19 December 2024

**32-38 & 40-50 ROKEBY STREET, COLLINGWOOD
 PLANNING PERMIT PA2402824
 SECTION 72 AMENDMENT APPLICATION**

This application is a request to DTP, pursuant to Section 72 of the Planning and Environment Act 1987 ('Act') to amend the Permit and substitute amended plans for endorsement. This application follows a supportive pre-application meeting with DTP officers on 27 August 2024, in which the proposed amendments were supported in-principle. This meeting was aided significantly by the attendance and involvement of the MA+Co design team who are retained for this project and the proposed amendments.

Figure 1 – Approved and proposed building - comparative render.

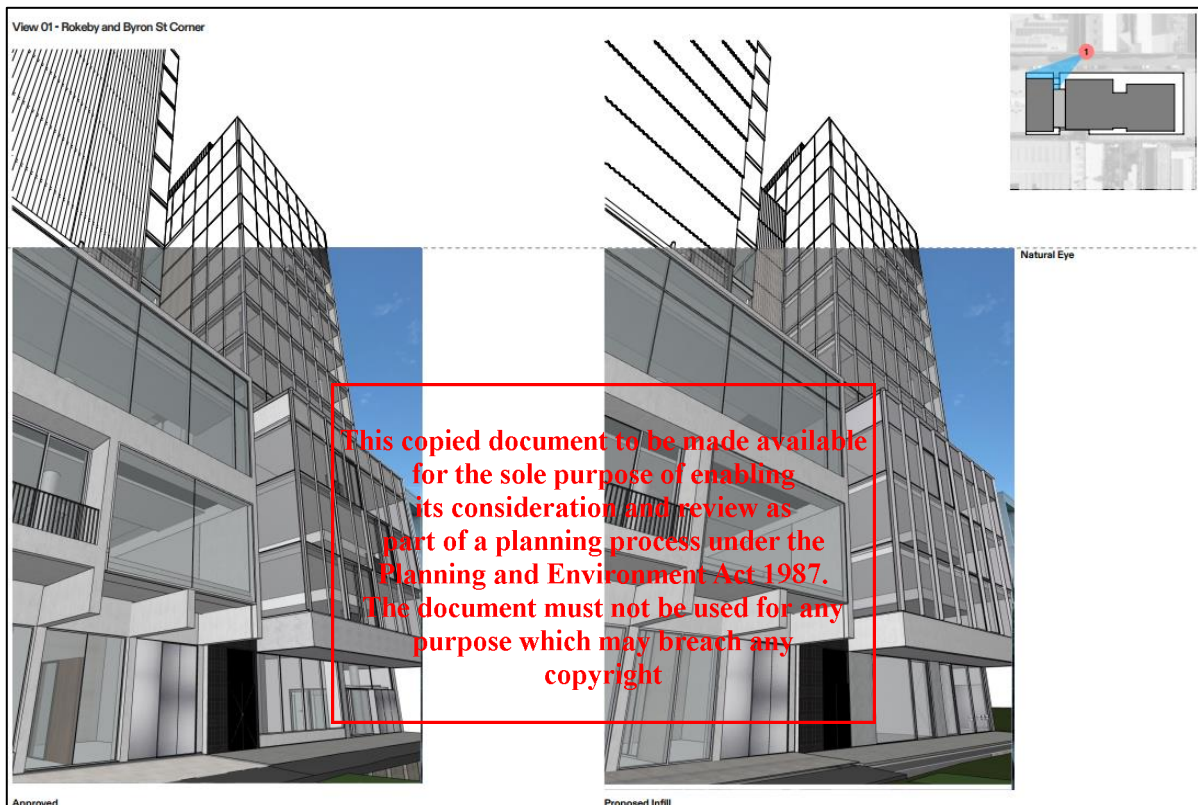
- Infill form between north and south tower, comprising seven levels above podium. The floor area of this additional form will be delineated through the middle of both the north and south tower. It will be treated with a metal cladding outer, which complements the palette of the tower forms, however, is also easily distinguishable. The additional form will be significantly setback to the Rokeby Street frontage and rear laneway, so that it is recessed behind the primary facade lines. As a result, there will be limited visibility of the form in streetscape views.
This copied document to be made available for the sole purpose of enabling its consideration and review as part of a planning process under the Planning and Environment Act 1987. The document must not be used for any purpose which may breach any copyright

- The proposed infill form is highly recessive and is set back a minimum dimension of 4.85m and 5.41m from the western facades of the northern and southern towers, respectively. Its positioning has been strategically designed so to minimise its visibility from the surrounding street network. As the comparative diagrams at pages 17, 18 and 19 of the accompanying design statement demonstrate, the additional form is unlikely to be viewed in many of the primary short and long-distance sightlines. An example is provided at Figure 1 below, which illustrates the minor degree of change which is contemplated by the amendment.
